System Impact Assessment Addendum

Project: Greenfield South Power Project

CAA ID 2004-178

February 17, 2009

Figure E-1:
G1 Exciter - Open Circuit Test -5% Vref Change
 Required Efd after 50 ms is -3.28 pu.

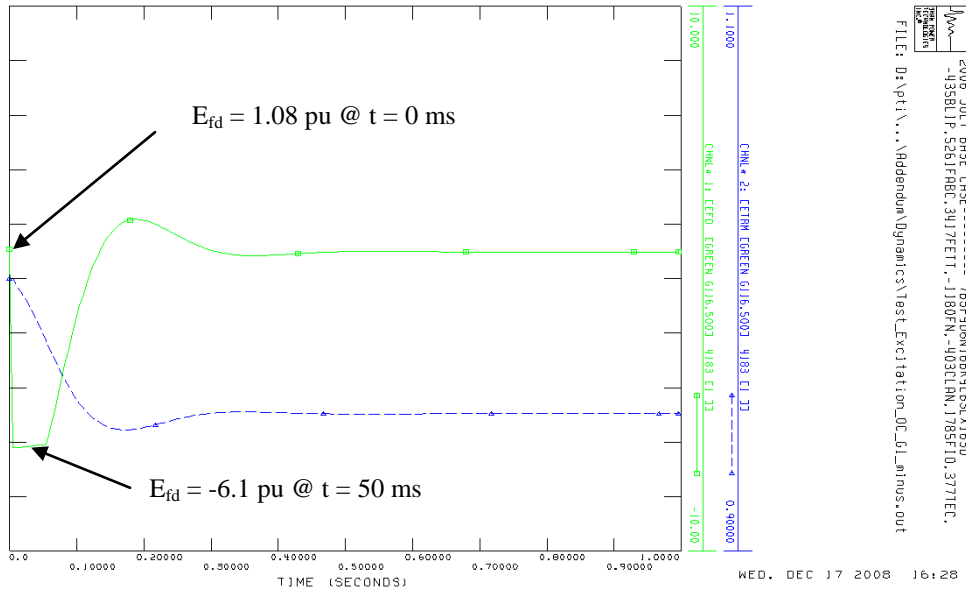
While the G1 excitation system was found to meet the Market Rules requirements, the G2 excitation system could not meet the negative Efd response time requirements for a 5% negative Vref change under the open circuit test.

Figure E-2:
G2 Exciter – Open Circuit Test -5% Vref Change ($K_A=600$; $K_M = 2$)
 Required Efd after 50 ms is -3.91 pu.

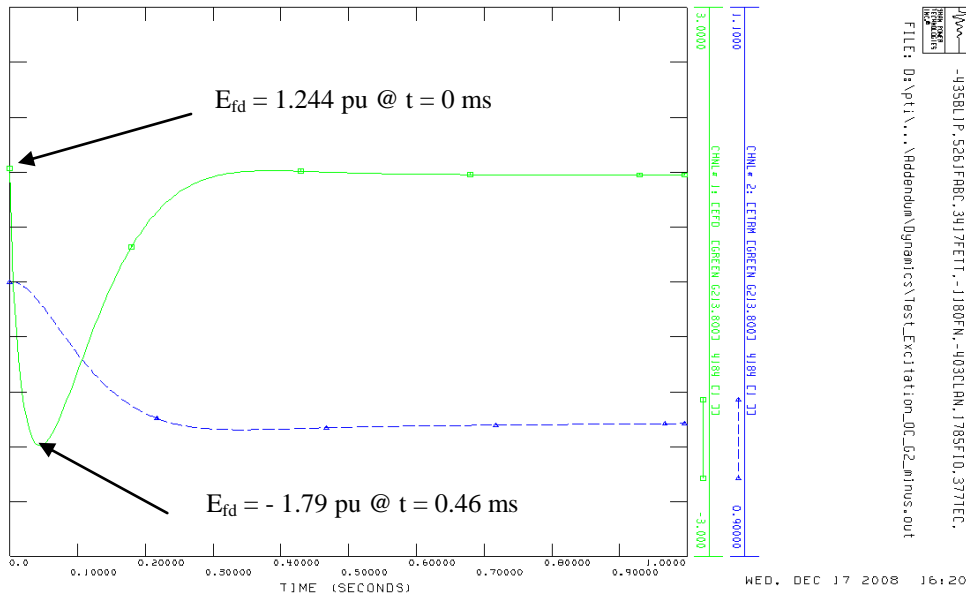
9. The Applicant has to review the G2 excitation system model and its parameters and ensure that it meets the Market Rules requirements, including those for negative Efd ceiling and the response time for a negative Vref change, before the final approval for connection is granted.

The Applicant has to review the G2 excitation system model and its parameters and ensure that it meets the Market Rules requirements, including those for negative Efd ceiling and the response time for a negative Vref change, before the final approval for connection is granted.

It is recommended the Applicant to provide the IESO with the revised G2 excitation system model and its parameters as soon as they become available, to allow the testing of the excitation system against the Market Rule requirements.
